TECHNICAL MEMO

SUBJECT: 40 Beechcliffe Street Site Plan - Stormwater Management Facility (SWMF) Design and Volumetric Analysis

OUR FILE: 24-1416

CITY FILE: D07-12-25-0091

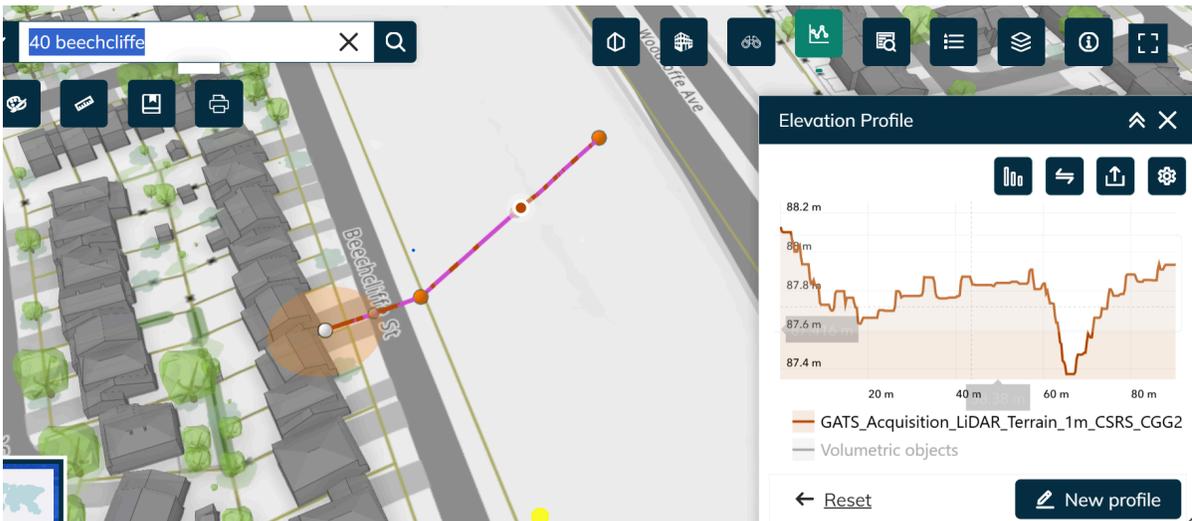
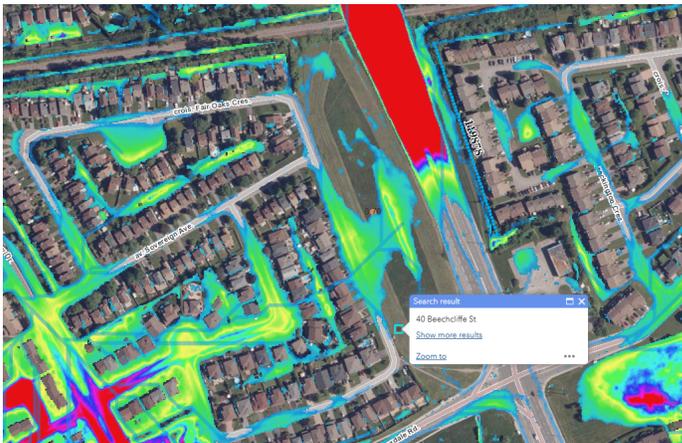
As mentioned over the phone, this site was providing storage relief to the overland flow from Beechcliffe Street under existing conditions. See image below. The proposed development will not only remove this existing storage but also add more flow to Beechcliffe Street. Therefore, we believe the total capture required in the ROW minor system will be much greater than what is described in the email below to ensure there is no negative impact on existing properties from the increased overland flow.

We understand the entire road will need to be excavated to replace the water main, sanitary, and add service laterals. That provides an opportunity to add road sags in the ROW, which could offset the loss in storage and the increased runoff from 40 Beechcliffe

Also, under existing conditions, the Beechcliffe overland flow would spill on the East Side (40 Beechcliffe) before it spills on the West Side. The proposed grade increase on 40 Beechcliffe will divert all of the emergency overland flow to the West Side. We need to ensure the proposed development does not increase the flow rate or volume of water that will spill on the West Side.

In summary, we would like the applicant to explore options to maximize the storage in the ROW to ensure the properties on the West Side are not negatively impacted. Due to the limitations in the Pinecrest Creek/Westboro sub-watershed study, we cannot increase the capture in the minor system.
